Re: Comments by Oracle Corporation on Draft 1 for the Energy Star Specification for Computer Servers Version 2.0

ORACLE CORPORATION COMMENTS ON THE EPA ENERGY STAR FOR SERVERS VERSION 2.0 SPECIFICATION (DRAFT 1)

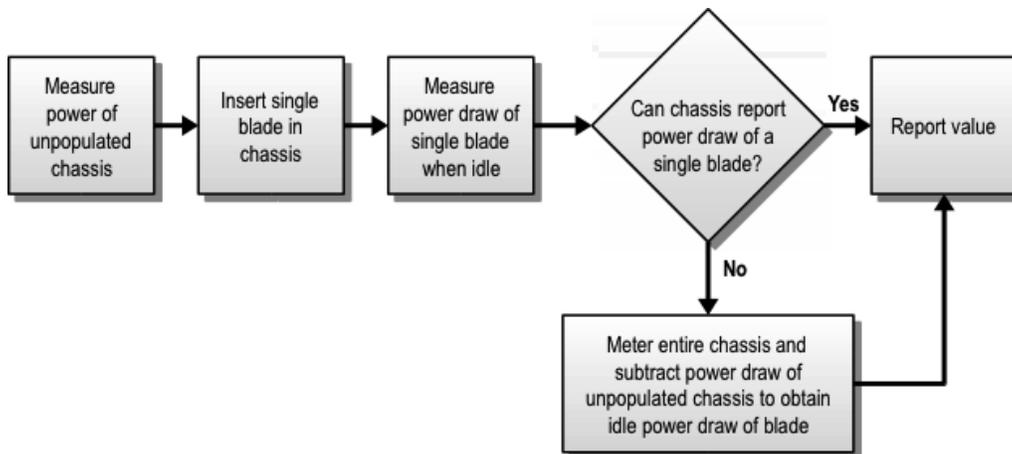
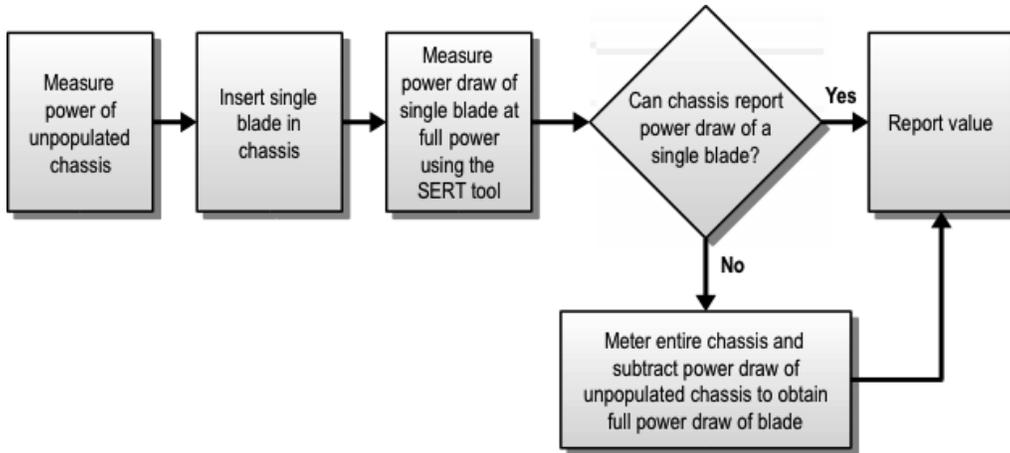
- **Blade Power Reported by Chassis:** Some chassis are capable of reporting the power draw of each individual blade in a bay. However, the power measurement mechanisms

that are built into such a chassis to measure the power draw of each individual blade do not necessarily meet the EPA's criteria for power analyzer accuracy. The EPA should clarify whether or not measurements of blade power taken from the chassis' built in power reporting mechanism will be acceptable for the purposes of Energy Star qualification, or whether the EPA will require the power measurement of each individual blade to be externally metered using a power analyzer with the accuracy specified by the EPA.

- **Blade Power Not Reported by Chassis:** When a chassis is not capable of reporting the power draw of each individual blade in its bays, the EPA should clarify the methodology for metering the power of an individual blade. If it is permissible to measure the power of an individual blade using a subtraction technique, the EPA should explicitly state as much. Under these circumstances, the most practical way of testing the power consumption of an individual blade is to subtract the power consumption of an empty chassis as measured by an EPA approved external power analyzer from the power consumption of the same chassis when populated with a single blade.

- **Blade Power Measured in Test Fixture:** The EPA should clarify whether it is permissible to measure the power consumption of a single blade in a stand-alone passive test fixture, designed as an enclosure for a single blade only, without any of the other properties of a bay in a blade chassis (i.e. no network backplane, no fans, no internal PSUs, etc.).

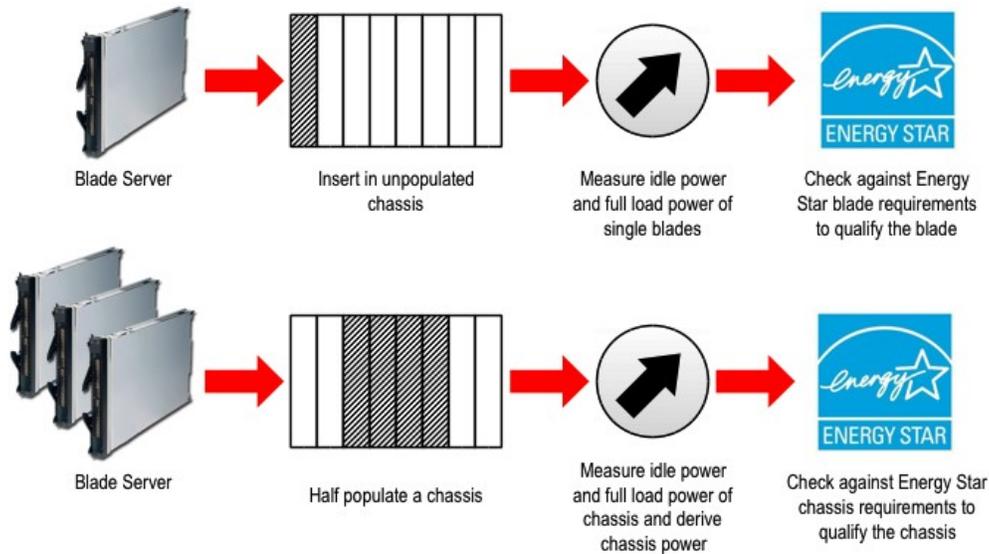
Our understanding of the blade testing methodology has been captured in the following diagram. We welcome the EPA's comments and feedback as to whether the following diagram correctly represents the EPA's intent.

Oracle Corporation would like to request the EPA's feedback on the methodology described in the subsequent diagram for conducting the following tests:

- Idle power of a single blade
- Full power of a single blade
- Overhead power of the chassis when all populated blades are idle
- Overhead power of the chassis when all populated blades are at full power

The above diagram represents Oracle's understanding of the methodology intended by the EPA for qualifying blade servers for Energy Star and for qualifying blade chassis for Energy Star. If the above diagram incorrectly represents the EPA's intent, please provide feedback accordingly. If the above diagram correctly represents the EPA's intent, Oracle has the following further questions about measuring the full power draw of a half-populated chassis:

- Should the full power of the chassis be measured by running the SERT tool on all the blades?
- The SERT tool is a composite workload, that is, it stresses different resources on the blade server at different times. During different periods of its operation, the SERT tool stresses CPU resources, memory resources, I/O resources, and disk resources in sequence. It is expected that the power draw of any blade running the SERT tool will be different depending on the phase of execution of the SERT tool. Should the vendor report the maximum power draw of the blade during this test, or the average power draw over the entire duration of execution of the SERT tool?

- Should the SERT tool be started on all the blade servers simultaneously, or is some variability in the start times permitted? (Note that because the SERT tool causes the blade to draw a different amount of power at different times in its execution cycle, running the SERT tool in a non-synchronized manner on all blades will lead to non-reproducible sequence of power readings at the chassis level.)
